ZUNIL GRAVITY STUDIES

ZUNIL GEOTHERMAL AREA, GUATEMALA

REVIEW COMMENTS

June 1, 1989

Figure 4. Summary of INDE and JICA electrical resistivity results, Zunil area.

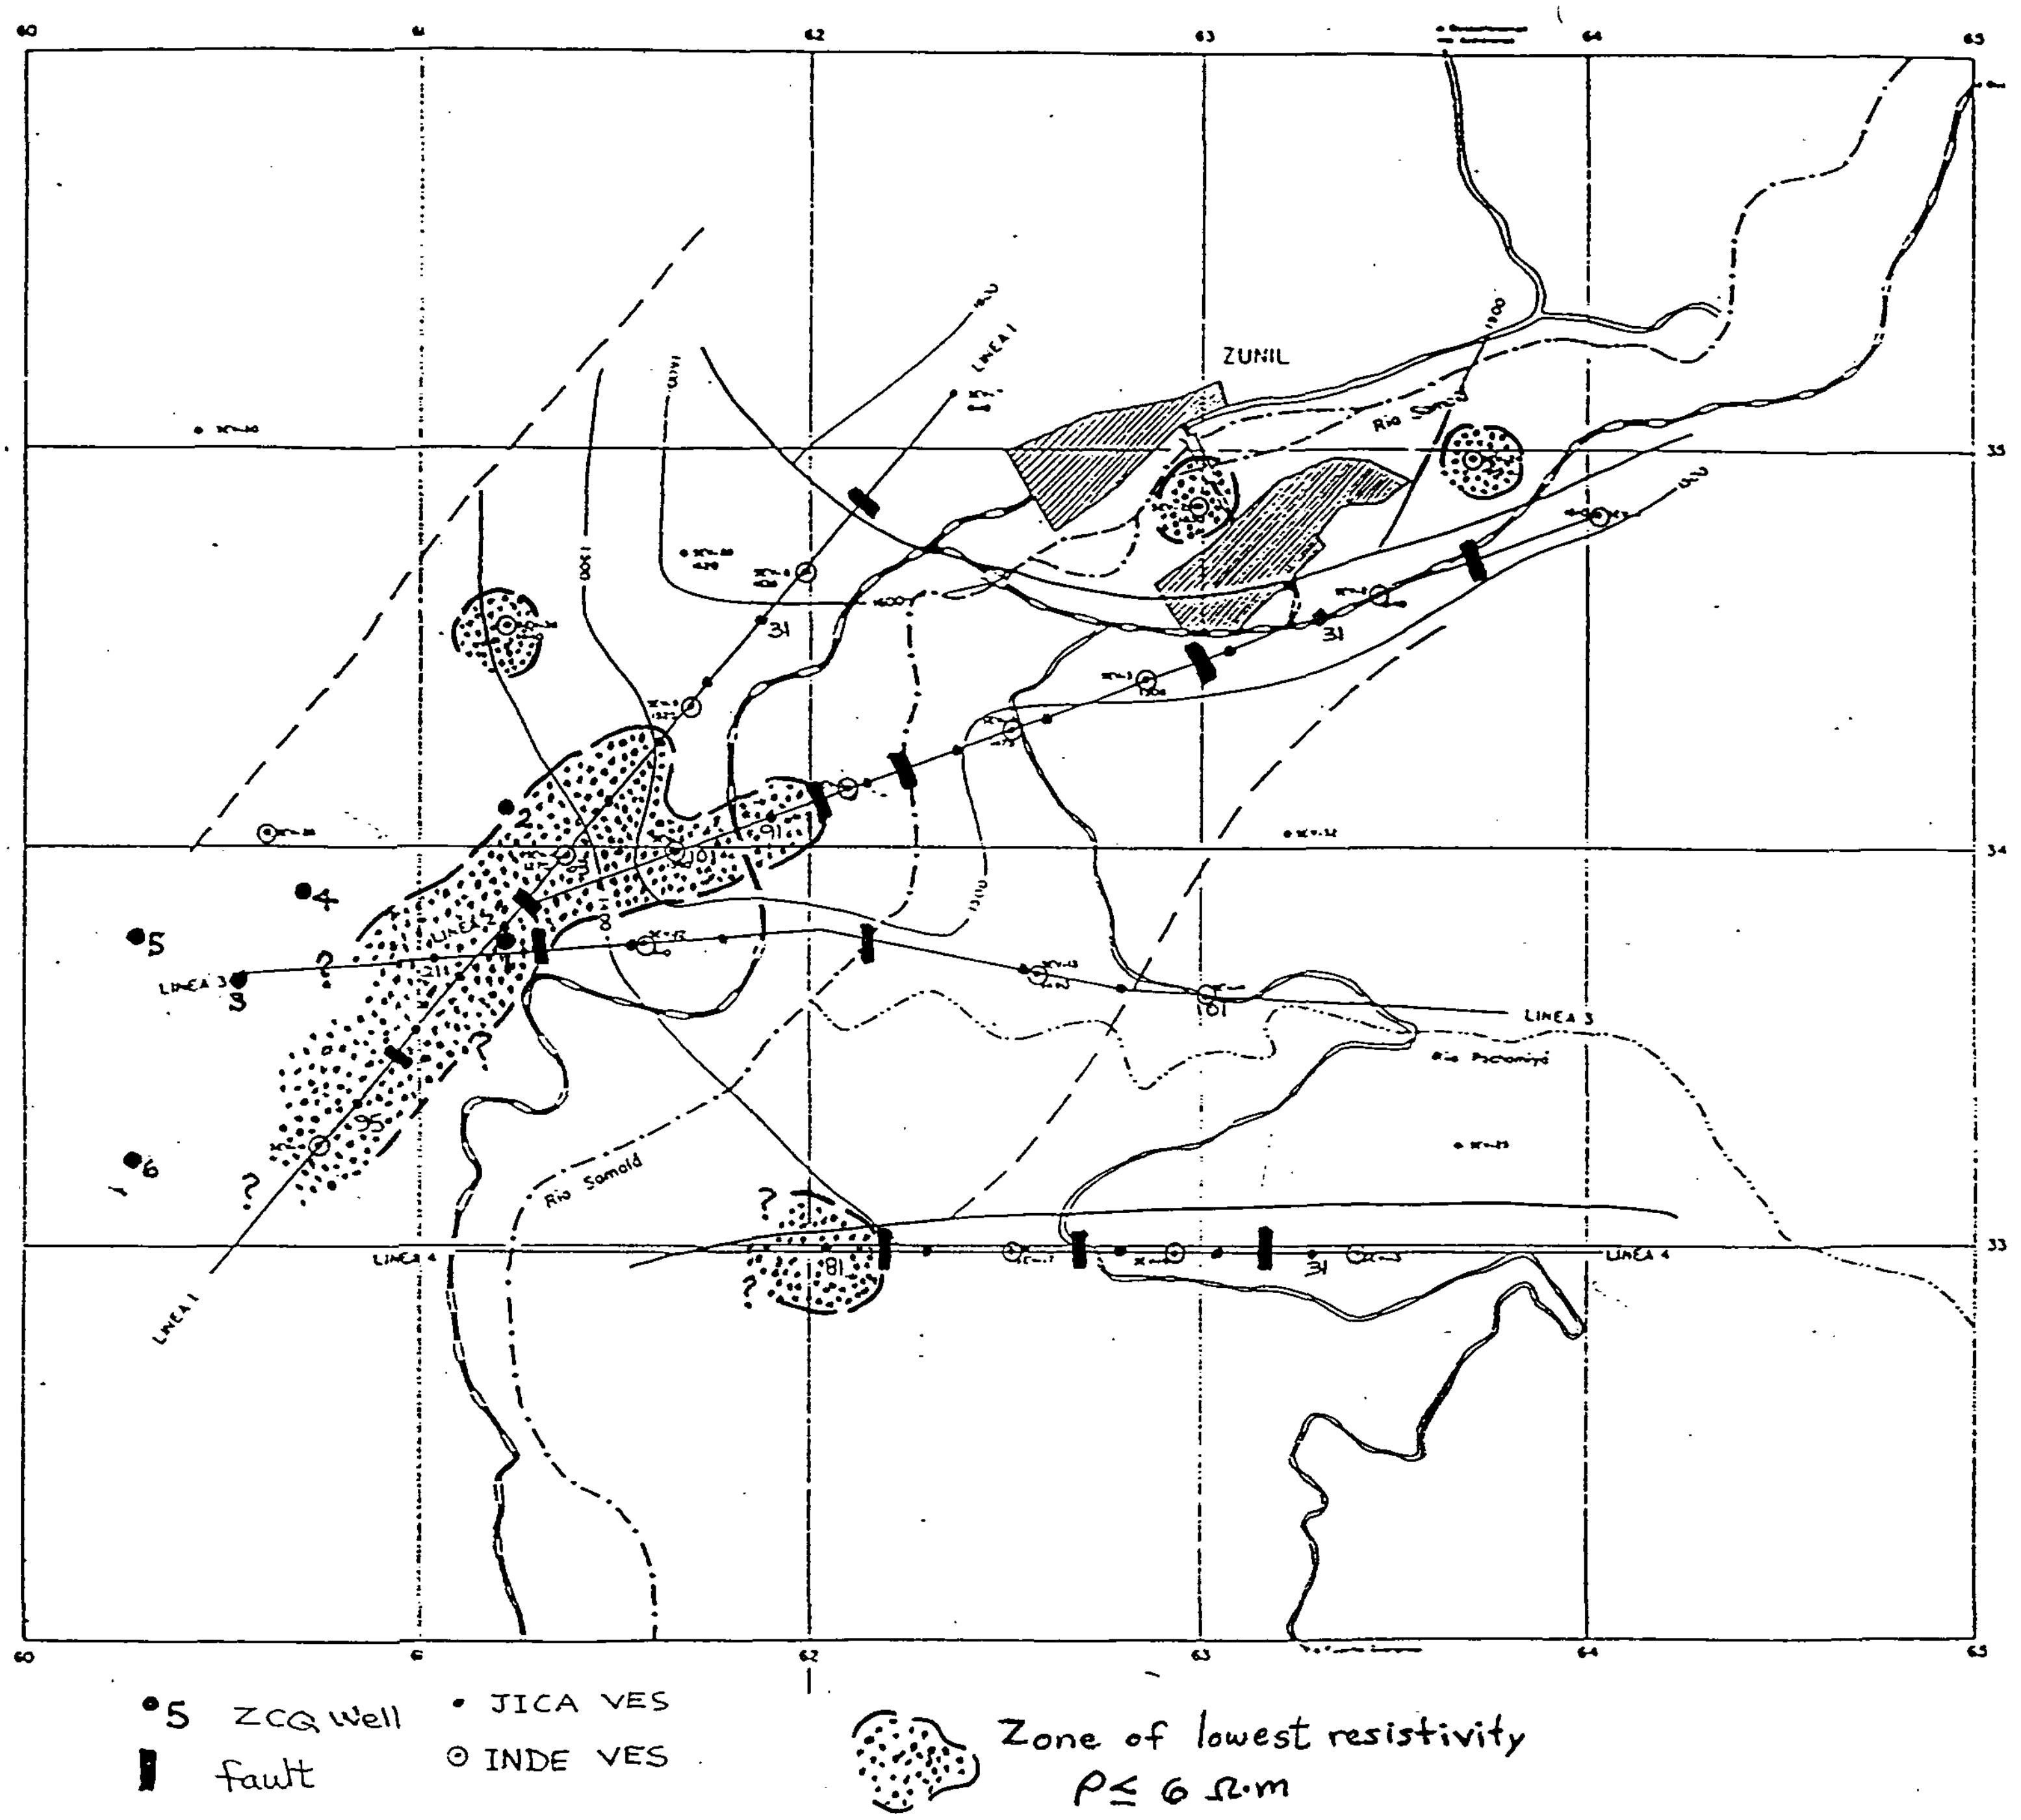
Figure 4 summarizes the principal results of the INDE and JICA resistivity data. Discontinuities betwen resistivity layers are interpreted as faults on Figures 2 and 3, and these have been transfered to Figure 4. Unfortunately most of this information is east of the portions of the reservoir tested by ZCQ-3, -4, -5, and -6, due to the steep topography in the area which has been drilled. Projection of the interpreted faults to the northwest is of current exploration interest however. Since the position of the discontinuity can only be estimated between adjacent VES centers, the trend and continuity of the structures must be inferred from geologic and topographic information.

Several soundings indicate very low resistivities (1-6 ohm-m) in the conductive layer. These include VES 11, 10, and 9 on Line 1; the area between VES 6 and 4 on Line 2; west of VES 12 on Line 3, from JICA stations 21 and 31; and JICA station 81 on the west end of Line 4. These areas are important because the low resistivities may indicate hot, relatively undiluted reservoir fluids circulating near faults, and/or increased clay alteration resulting from geothermal fluids. These areas are shown on Figure 4.

Figure 4. Location of faults in the Zunil 1 area as inferred from the detailed gravity survey. This interpretation has not been supported by numerical modeling.

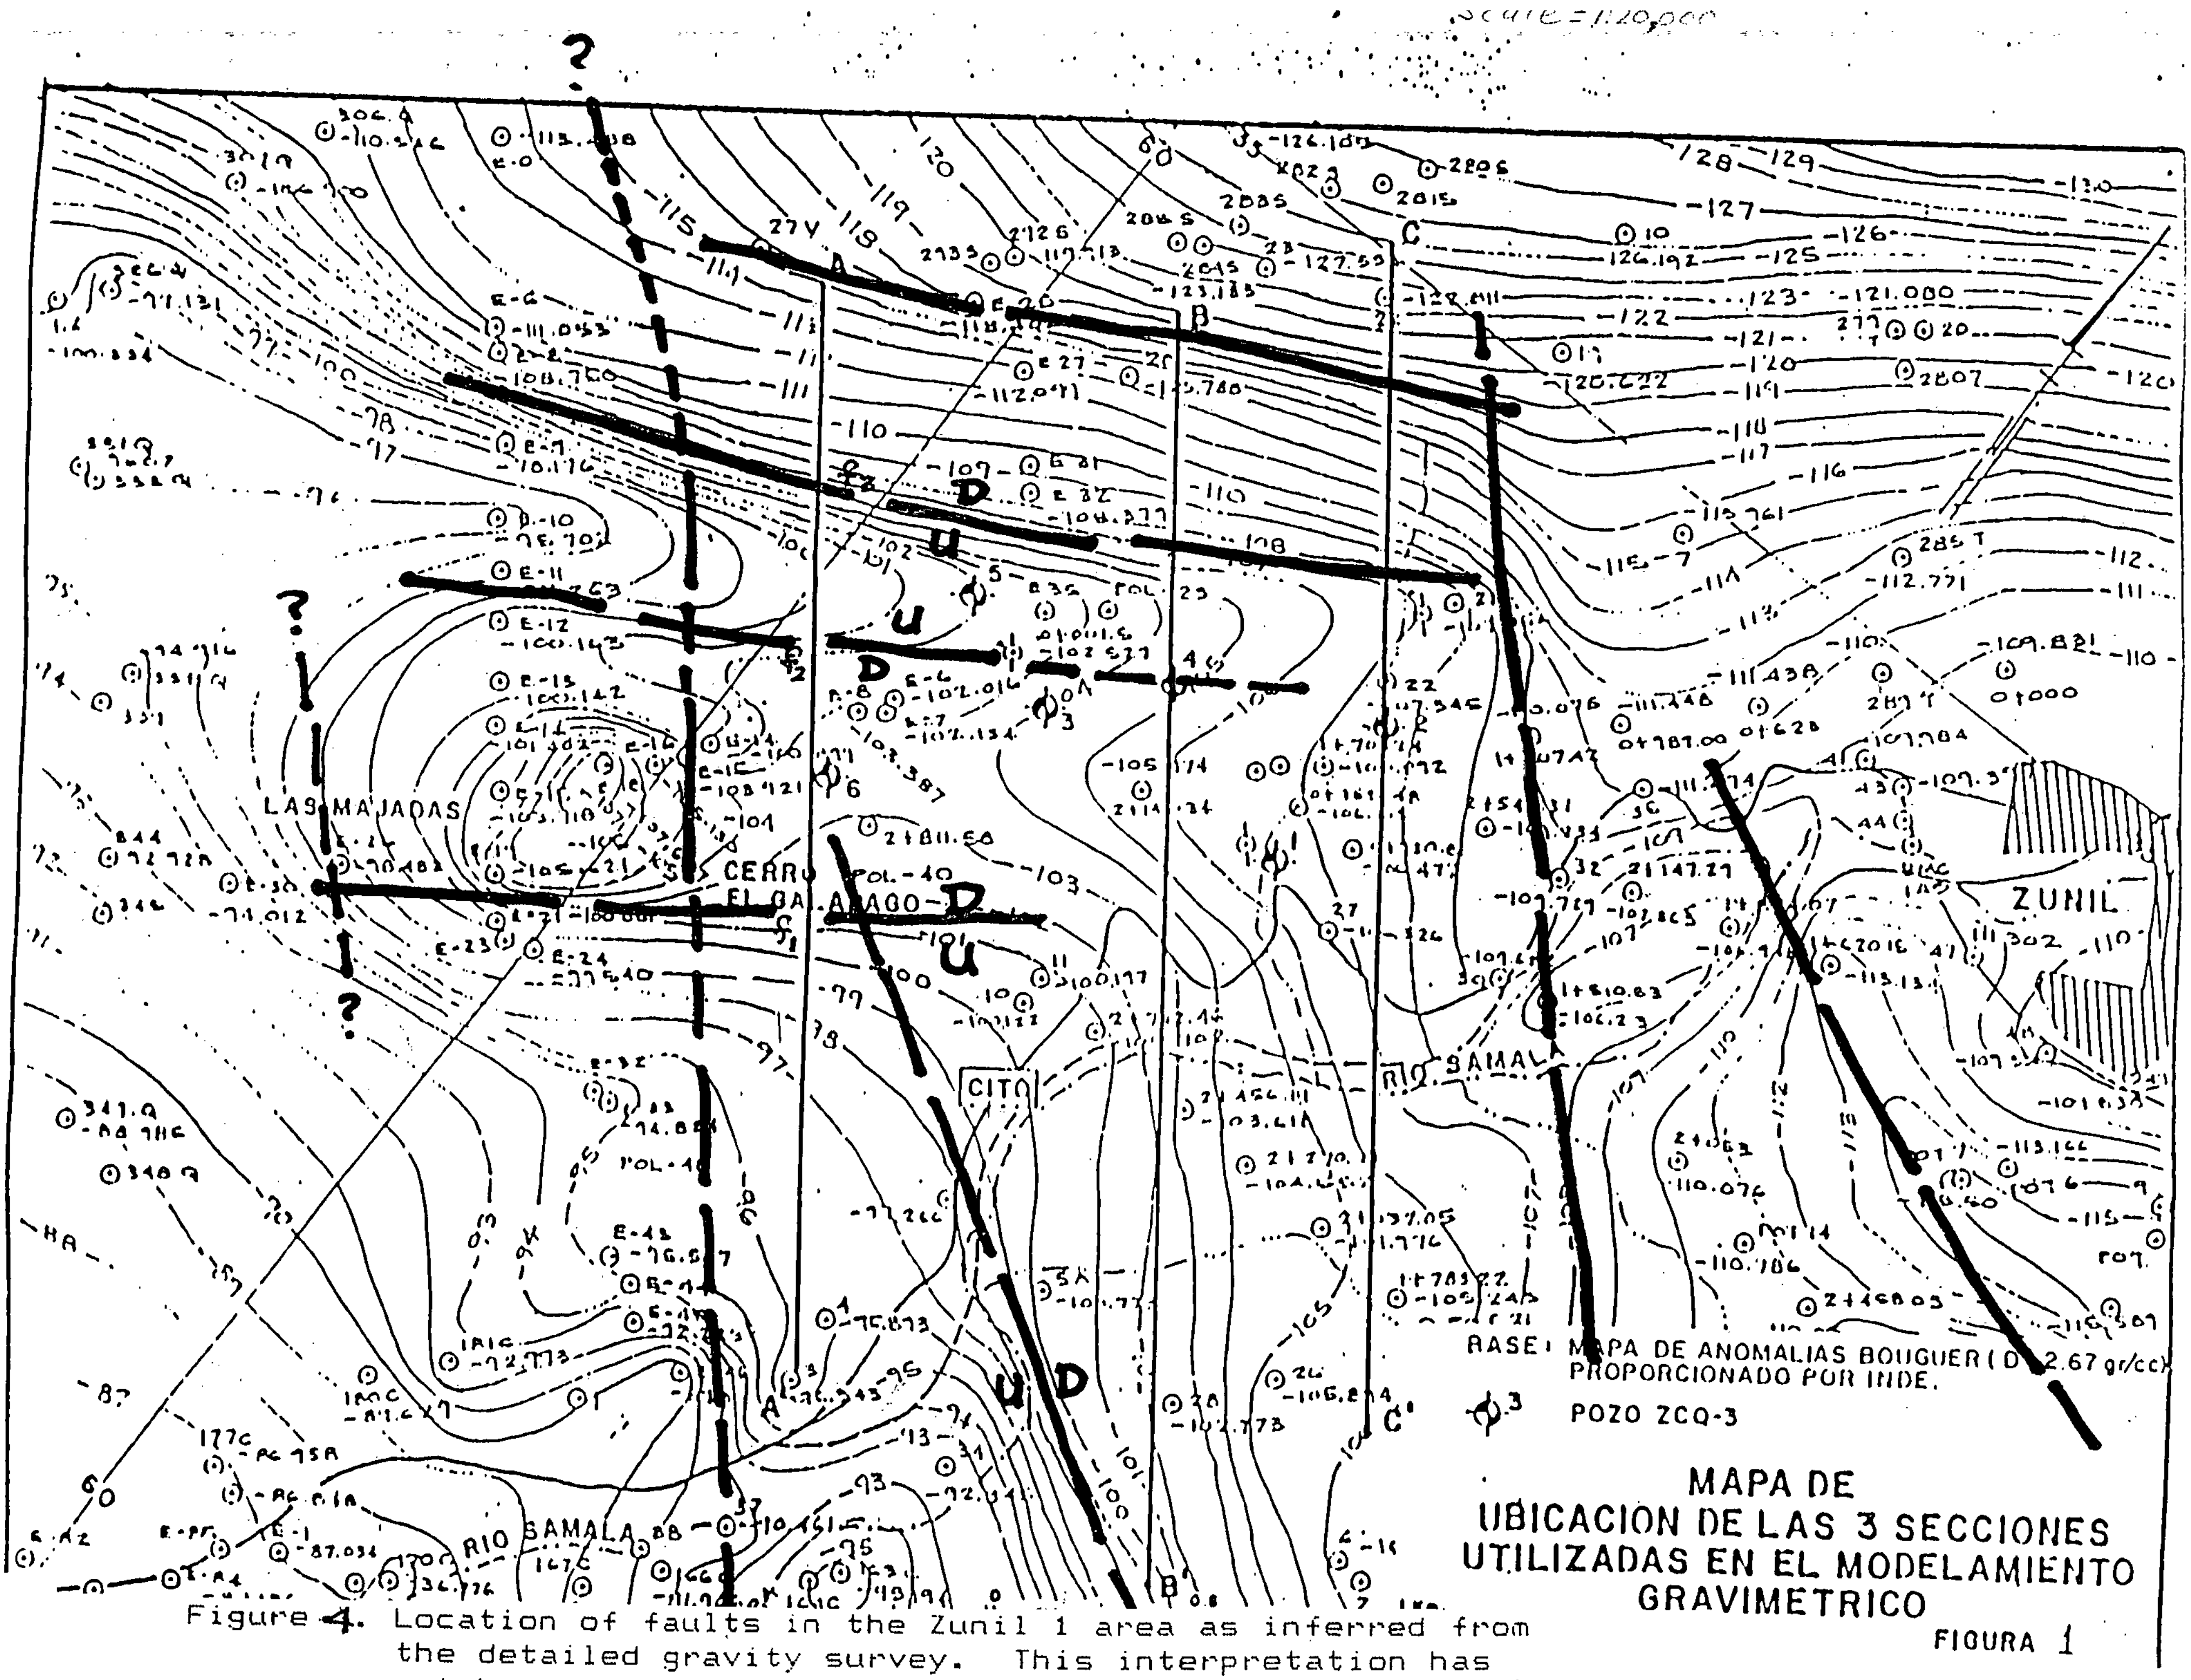
Figure 4 illustrates an alternative (interim) interpretation of fault locations suggested by the detailed gravity data. The positions of three faults interpreted from the residual anomaly of profile A-A' are indicated along this profile. While there is some agreement with structures previously interpreted by INDE, the position of some faults is different and additional northwest-trending structures are indicated. This qualitative interpretation assumes that the existing data are sufficiently accurate as presented (even with a 2.67 density and existing terrain corrections) to support the steep gradients indicated by the contour map. No new numerical modeling has been undertaken to support this interpretation, but some of the northwest trending structures agree with linear features that have been interpreted from topographic expression and aerial photos.

If the interpretaion of three faults just west of ZCQ-6 is correct, this may indicate a zone of considerable fracturing and permeability important to the siting of future production wells. The detailed gravity survey now in progress will provide detailed data with good elevation and location control suitable for in-depth numerical modeling to test this interim interpretation.
